**RELEASED FOR  
 FABRICATION / INSTALLATION**  
 PPPL Drafting:

Oak Ridge National Laboratory managed for the DEPARTMENT OF ENERGY under U.S. GOVERNMENT contract DE-AC05-00OR22725 UT-BATTELLE, LLC, Oak Ridge, Tennessee PROJECT NAME						
NATIONAL COMPACT STELLERATOR EXPERIMENT VACUUM VESSEL PERIOD INSPECTION AND LEAK CHECK ASSEMBLY						
VERSION NO.	PLANT	BLDG	FL	SHT OF	TYPE	CLASS
5	X-10	5700	3	2 19	A	U
RELEASE LEVEL		SE120-004			REV	
Fabrication					2

TYPICAL PORT 7A AND 7B SECTION PORT07-PORT07  
 $\varnothing .250$  A B C

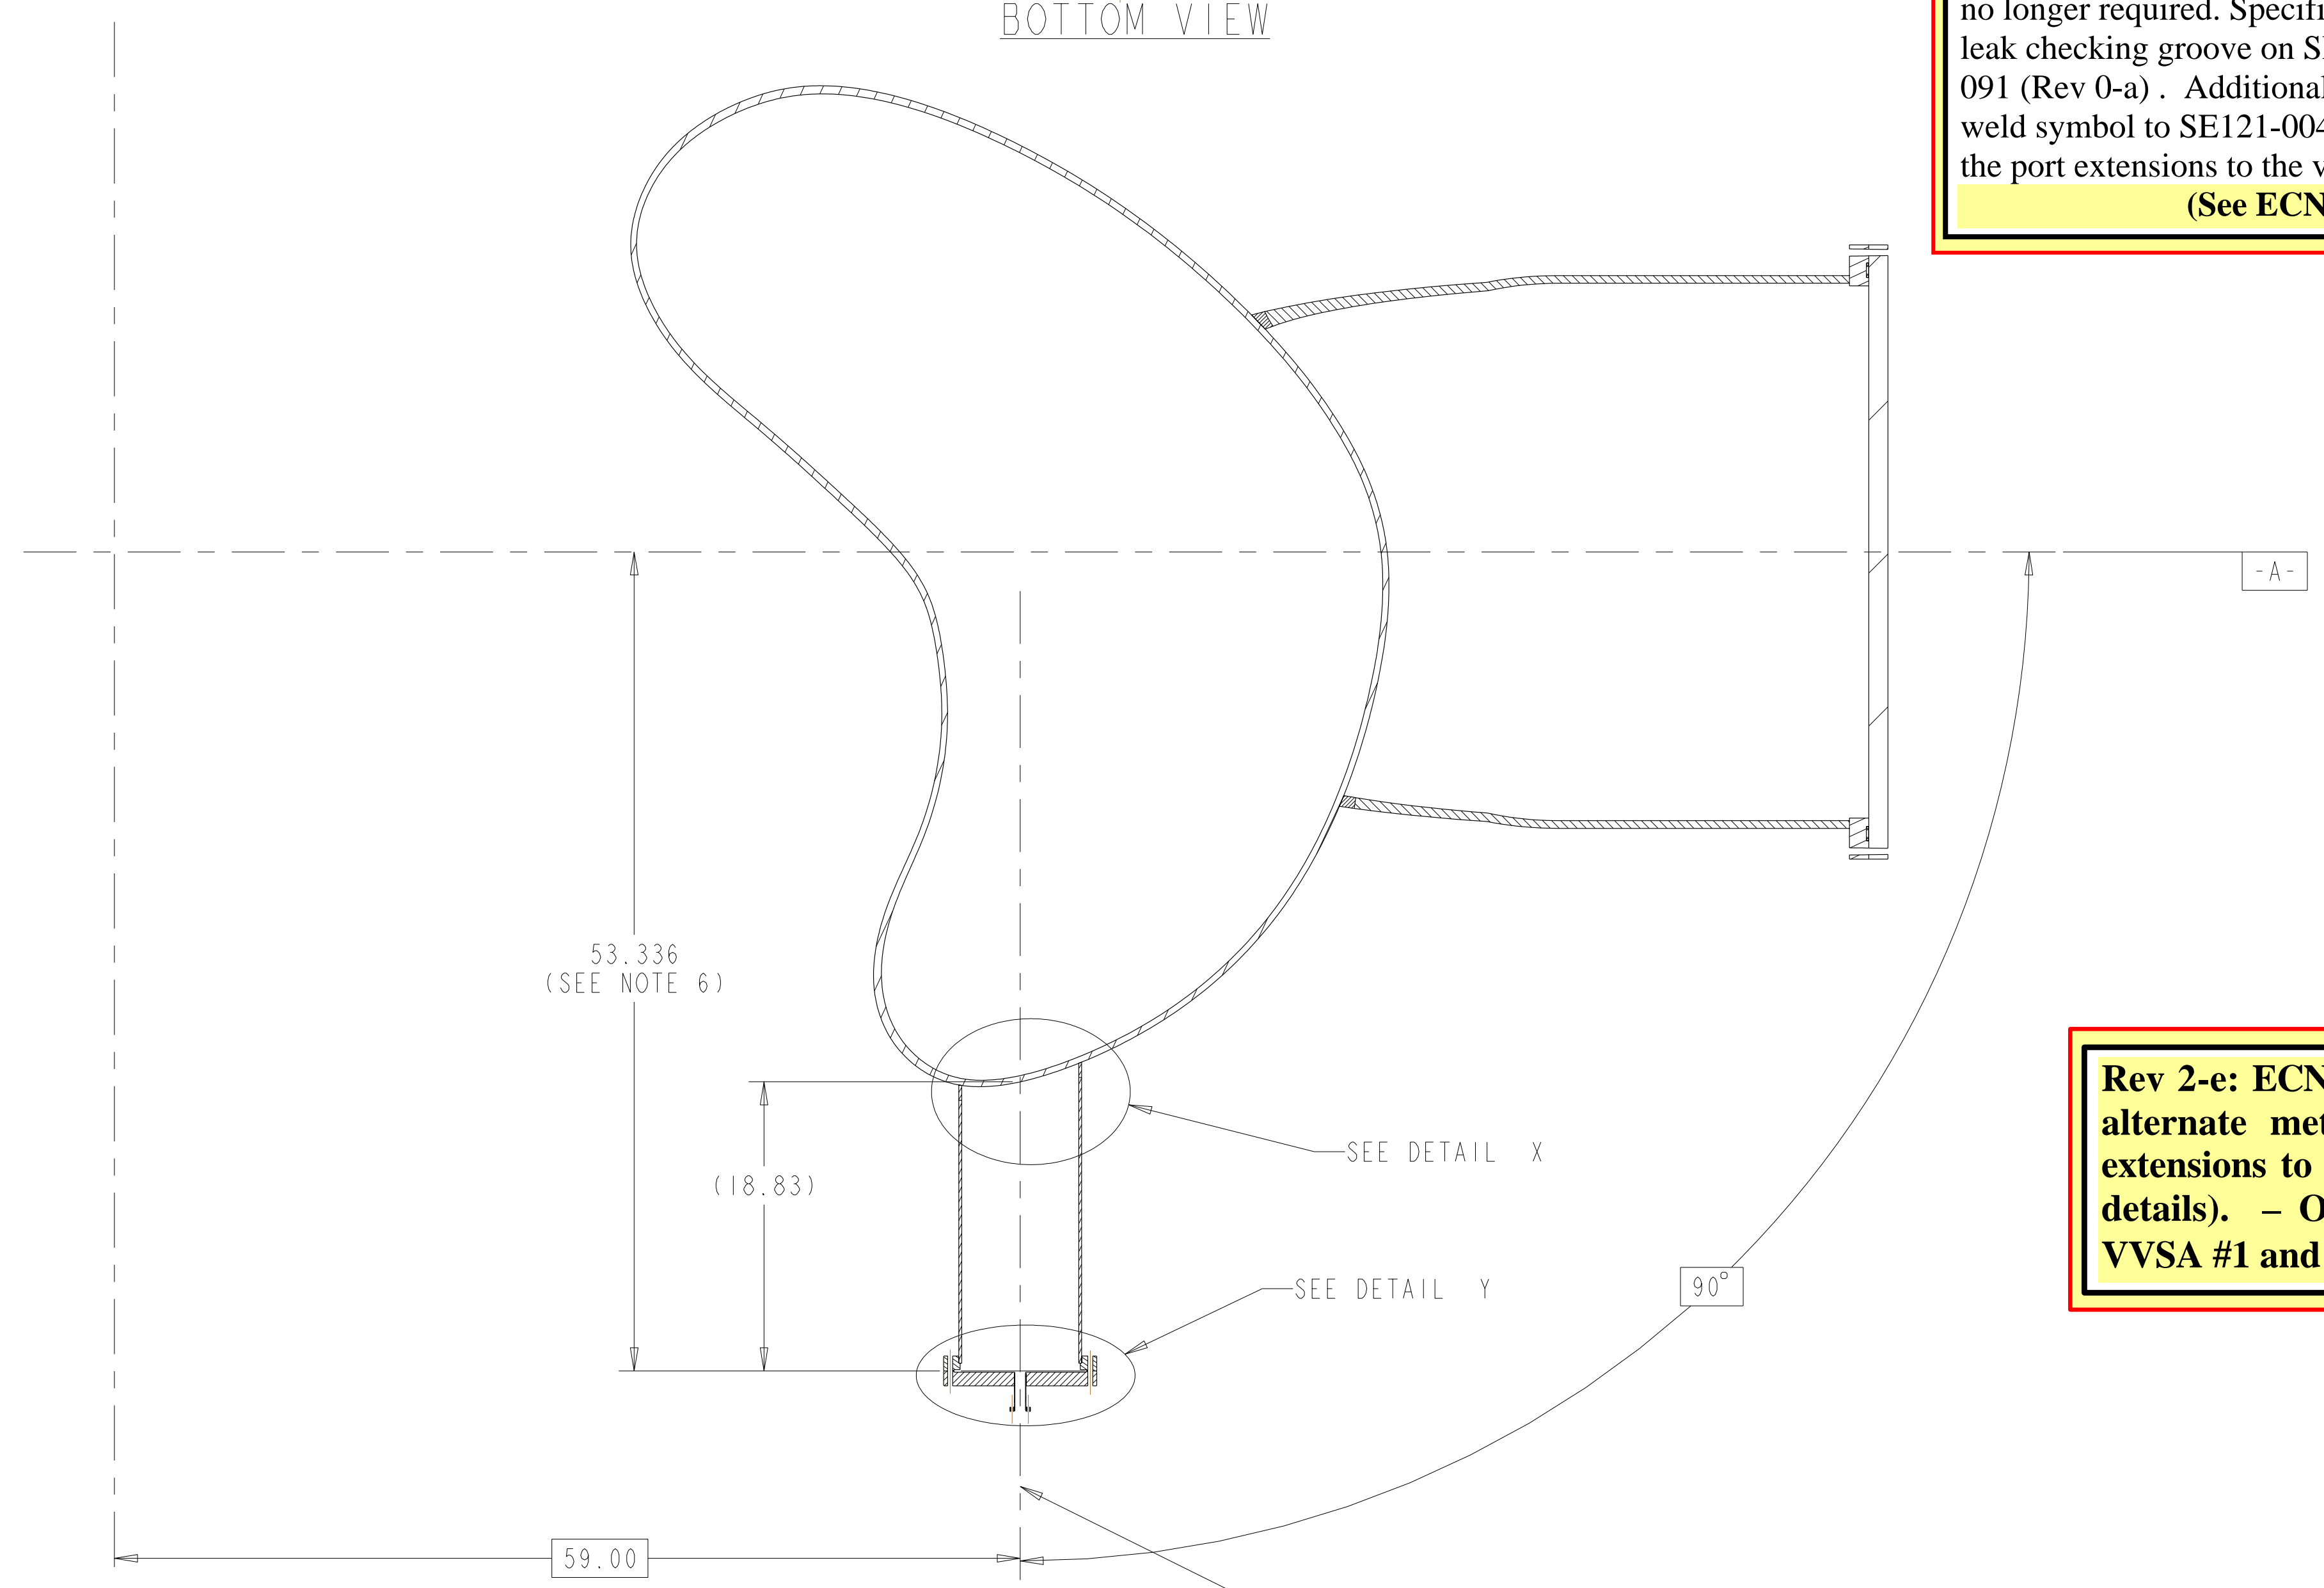
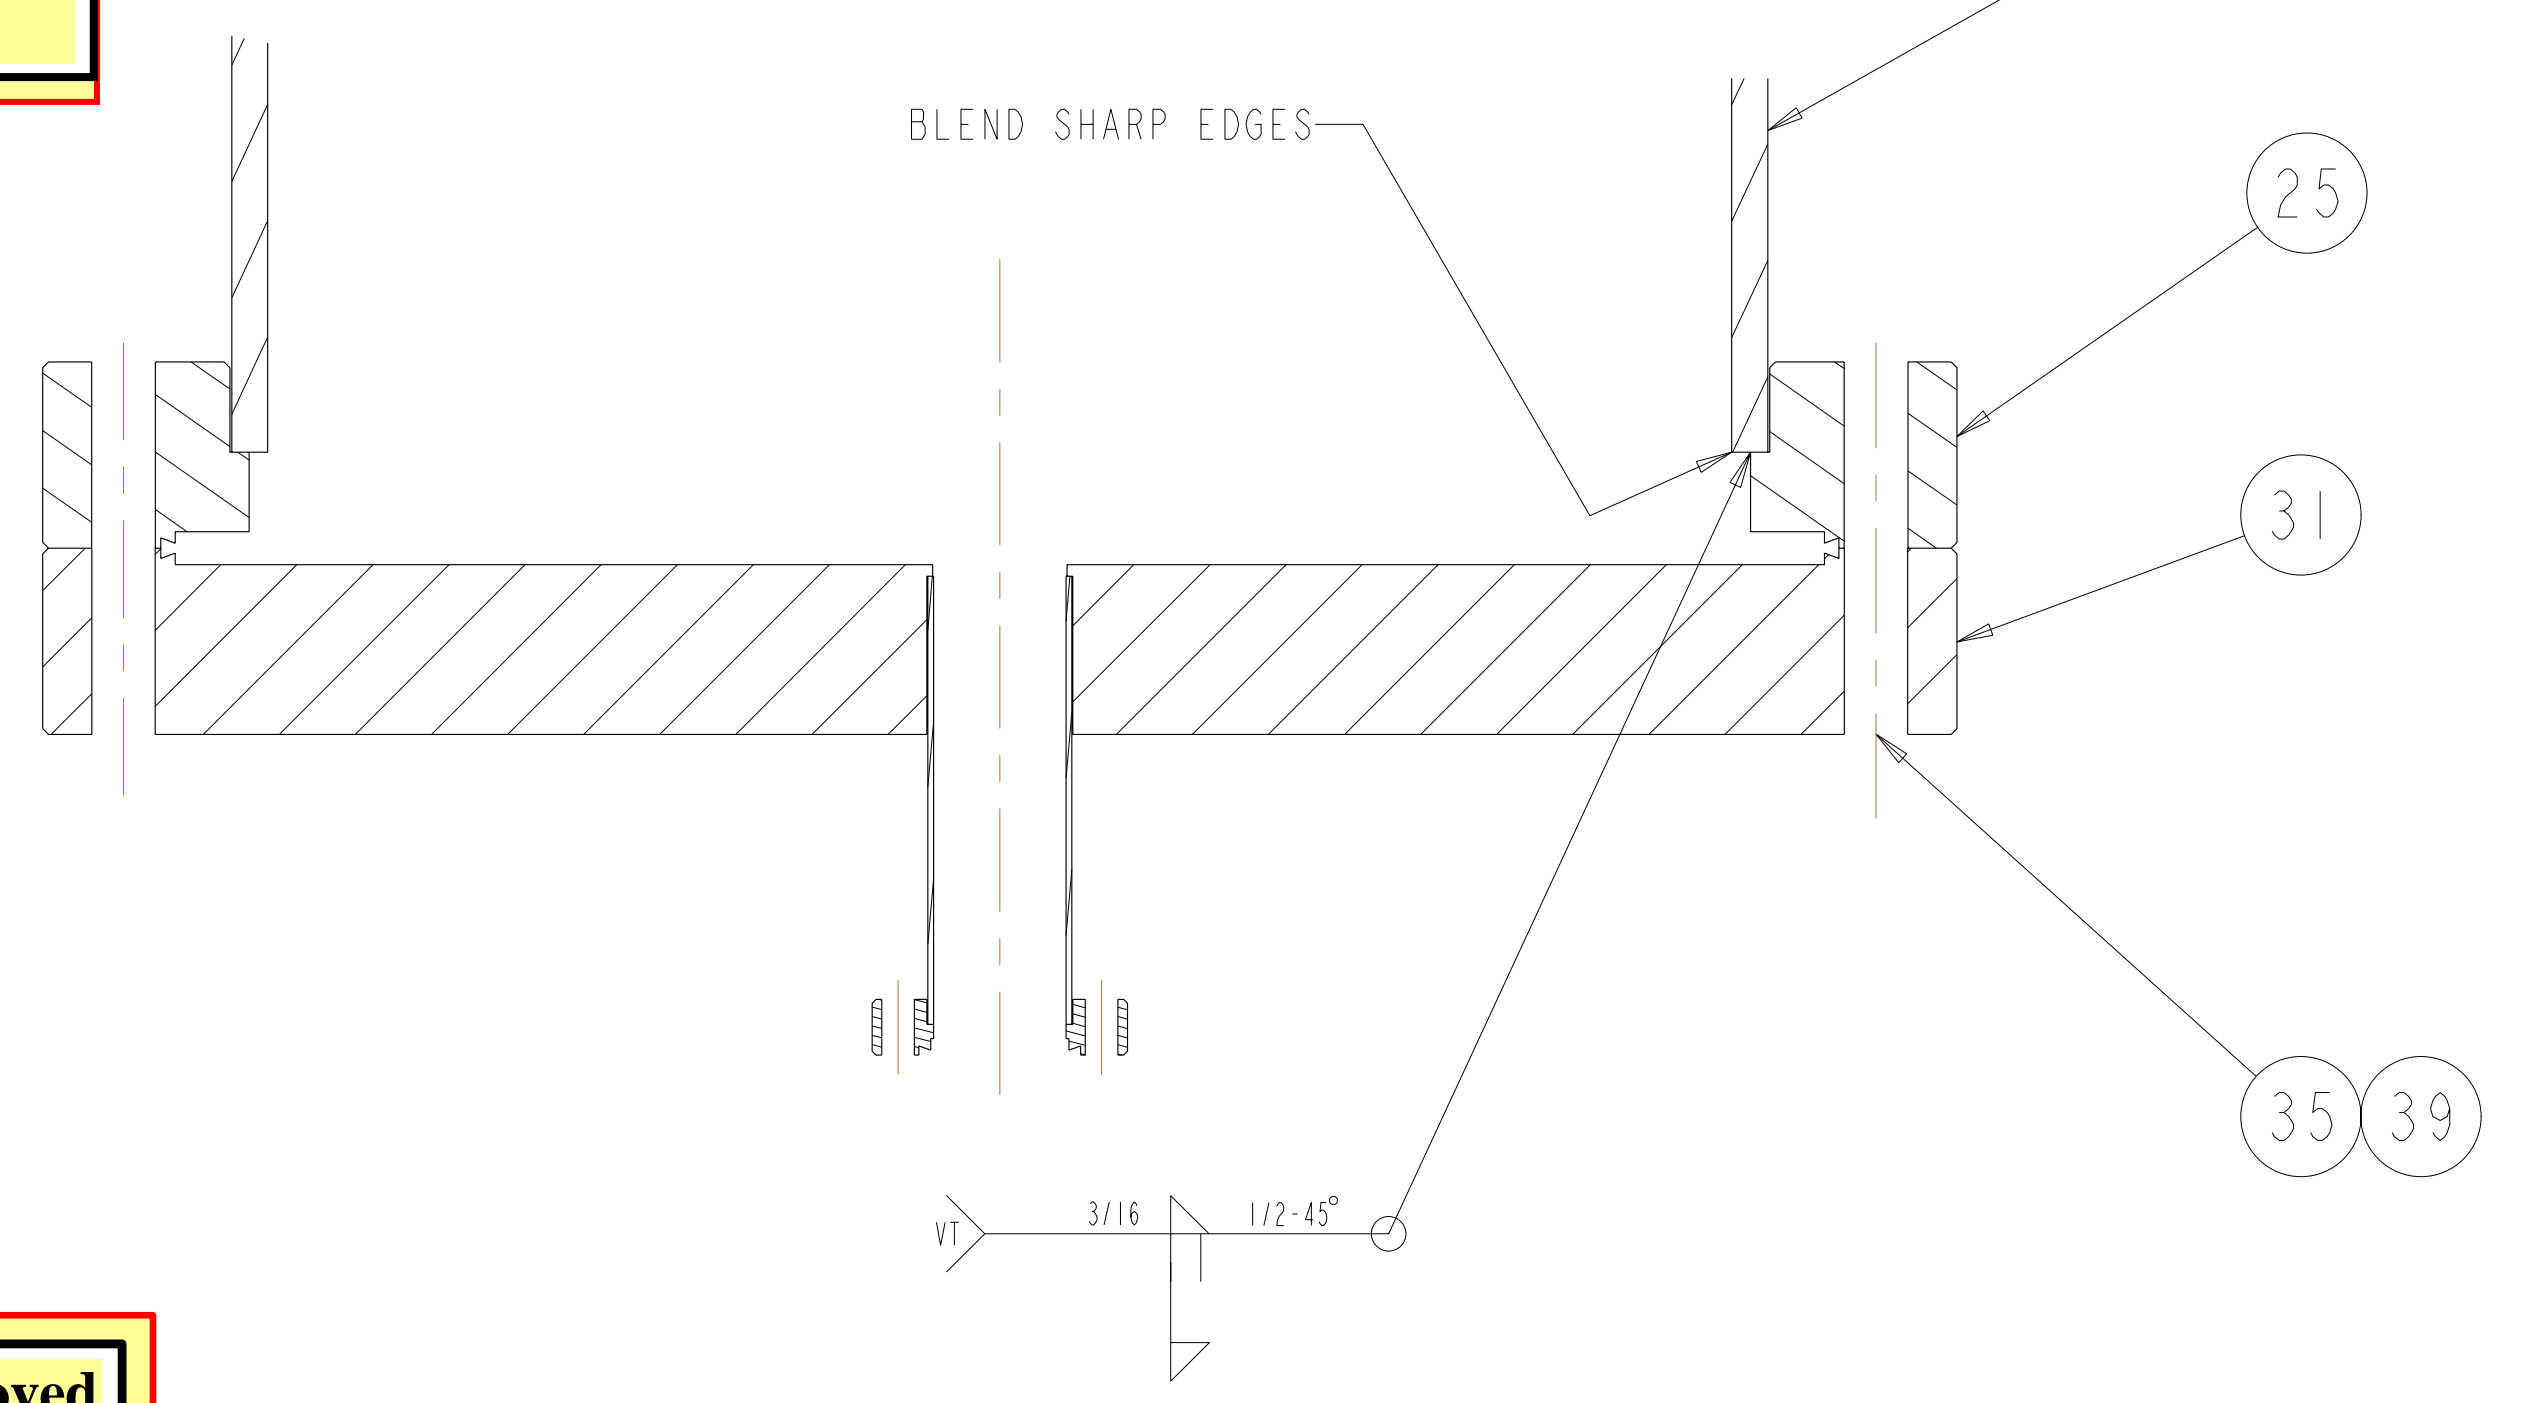
**ECN-5082.** Requirement originally included grooves to facilitate leak checking by vendor. However, vendor elected another means of leak checking and therefore the grooves are no longer required. Specifically, this ECN eliminated the leak checking groove on SE121-014 (Rev 1-c) and SE1221-091 (Rev 0-a). Additionally, this ECN added a missing weld symbol to SE121-004 (Sheets 4 through 19) for joining the port extensions to the vessel (Rev 2-d).  
 (See ECN-5082 for details)

**Rev 2-c: ECN-5021 (RFD-12-017) approved alternate methods for welding the port extensions to the VVSA (See ECN-5021 for details). - Only applicable to VVSA #3 - VVSA #1 and #2 covered by NCR 19464.**
